TESTIMONY

Re: ODOT OR 99W Northbound at I-5 Northbound Safety Project

Subject: Council Agenda Item 649 , Concerns re bicycle and pedestrian safety needs for this project

OR 99W Northbound at I-5 Ramps Safety Project

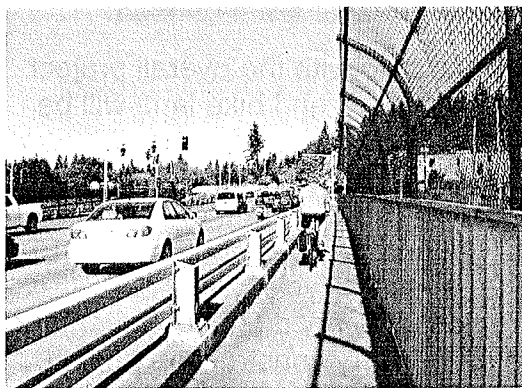
ODOT has modified the design to add a short bike lane and signage to make it safer for bicyclists to travel northbound, although bikes will be expected to ride in the vehicle travel lane or share the narrow sidewalk with pedestrians (see photo).
